Detailed Site Plan

DSP-03012-04

Application	General Data	
Project Name: ALDI, Inc., Hyattsville Location: Located within the southwest quadrant of the intersection of Hamilton Street and MD 500 (Queens Chapel Road), approximately 400 feet west of the intersection. Applicant/Address: ALDI Inc. 8751 Gas House Pike Frederick, MD 21701	Planning Board Hearing Date:	07/19/18
	Staff Report Date:	07/13/18
	Date Accepted:	05/14/18
	Planning Board Action Limit:	07/23/18
	Plan Acreage:	2.29
	Zone:	M-X-T/T-D-O
	Gross Floor Area:	20,567 sq. ft.
	Planning Area:	68
	Council District:	02
	Election District	17
	Municipality:	Hyattsville
	200-Scale Base Map:	206NE03

SUBJECT: Detailed Site Plan DSP-03012-04
ALDI, Inc., Hyattsville
Lots 3, 6, and 7 of Queens Chapel Triangle

SITE PLAN

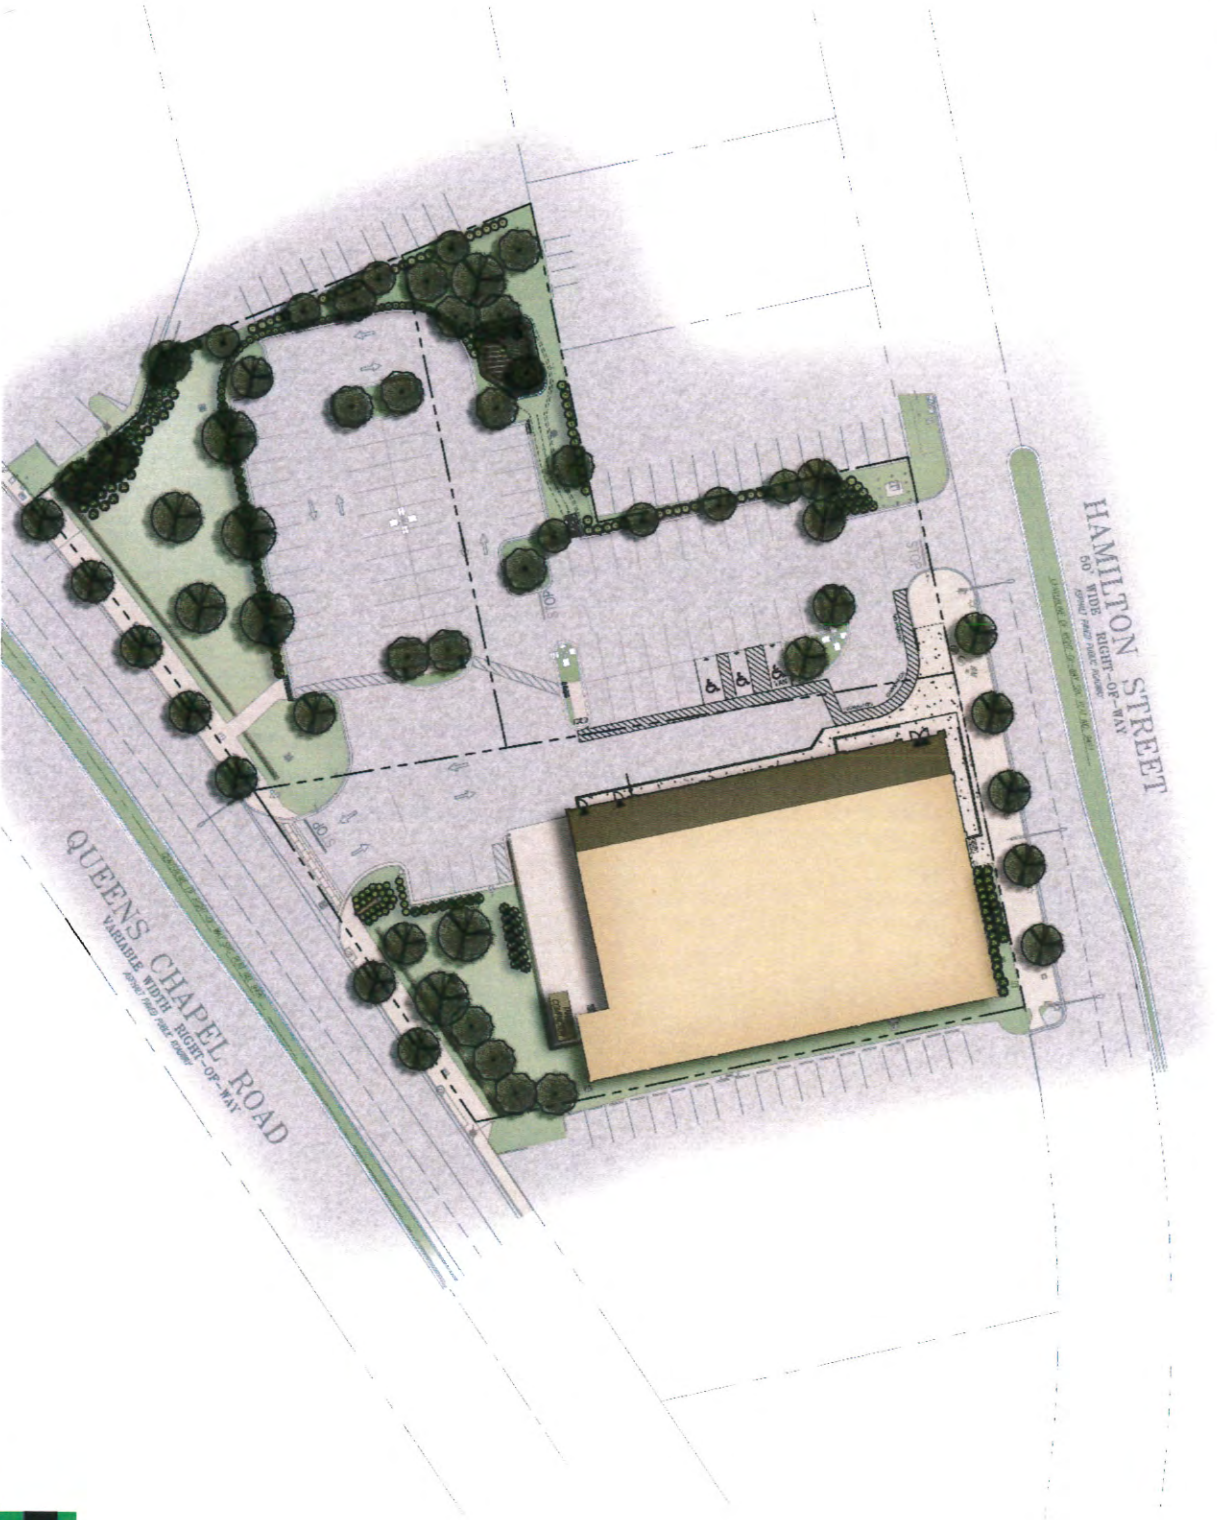
**The detailed site plan shows the required and proposed number of parking spaces, but has not broken the spaces out by type in the parking schedule for clarification. Therefore, a condition has been added to the Recommendation section of this report requiring the applicant to revise the parking schedule to show the number of required and proposed handicap-accessible spaces.

The Transportation Planning Section noted that Hamilton Street is a master plan collector facility and that Queens Chapel Road is a master plan arterial facility. For both, sufficient right-of-way has been previously dedicated or provided, and no structures are proposed within the ultimate right-of-way. Access and circulation are being slightly modified and are acceptable, as shown. The number of parking spaces will be reduced from 84 to 73 spaces; this adjustment is acceptable.

The conditions for the wide sidewalk and bicycle racks have been fulfilled. The current site has a robust pedestrian network connecting Queens Chapel Road and Hamilton Street to the entrance of the building. The connection from Queens Chapel Road to the building entrance does not have pedestrian ramps that meet current Americans with Disabilities Act (ADA) standards, including truncated dome pads. The applicant shall install ADA ramps at all appropriate locations along this pedestrian route, and the plans should be revised to include this modification.

1. Prior to certification of the detailed site plan (DSP), the plans shall be revised, as follows:
 - a. Update the parking table to reflect the proposed use, the number of required and proposed parking spaces, and parking space types.
 - b. Provide additional information showing that the proposed signage meets the requirements of the 2006 *Approved Transit District Development Plan and Transit District Overlay Zoning Map Amendment for the West Hyattsville Transit District Overlay Zone*.
 - c. Provide a schedule showing conformance to the Prince George’s County Tree Canopy Coverage Ordinance.
 - d. Add the following site plan notes:

ARCHITECTURAL ELEVATIONS & SIGNAGE

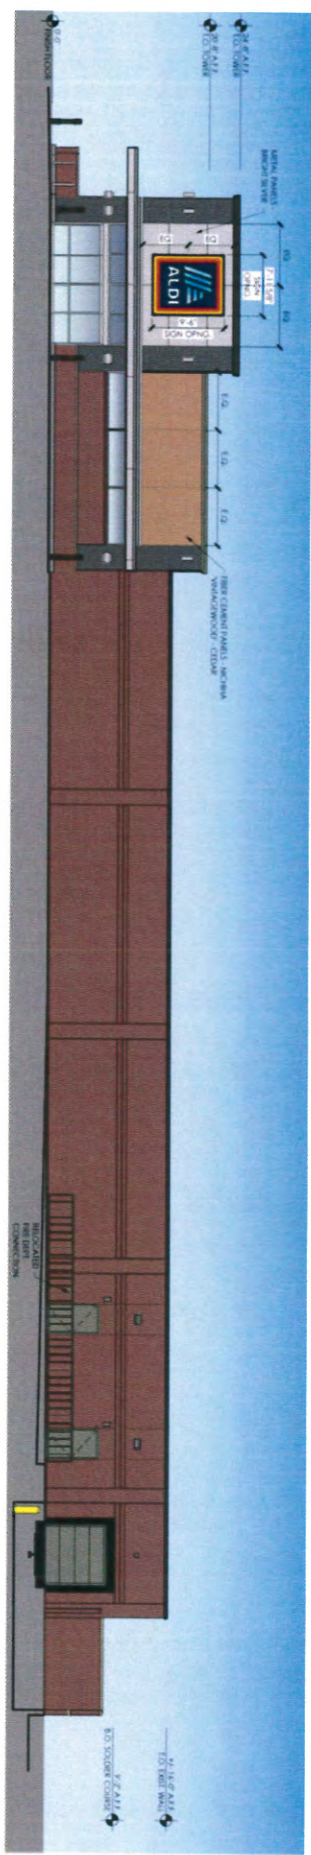
Staff notes that lettering for all signage is required not to exceed 18 inches in height, or width, in the West Hyattsville TDDP, and it is unclear if the application meets this requirement. Therefore, a condition has been included in the Recommendation section of this report requiring the applicant to provide additional information showing that the proposed signage meets the requirements of the TDDP.

Staff supports the amendment because the proposed building-mounted signs are in substantial conformance with what was approved with the original DSP-03012 application. The original signs were internally illuminated and were located on the northern and western building faces. These signs were subject to the 1998 *West Hyattsville Approved Transit District Development Plan*, and internally illuminated signs were permitted at that time.

The proposed signage is internally illuminated and being located on the same northern and western building faces, in a similar building placement on the proposed addition. The signage is only slightly larger than the existing signage and features a revised logo. Due to the similar building placement, illumination, and size, staff recommends **approval** of the amendment request.
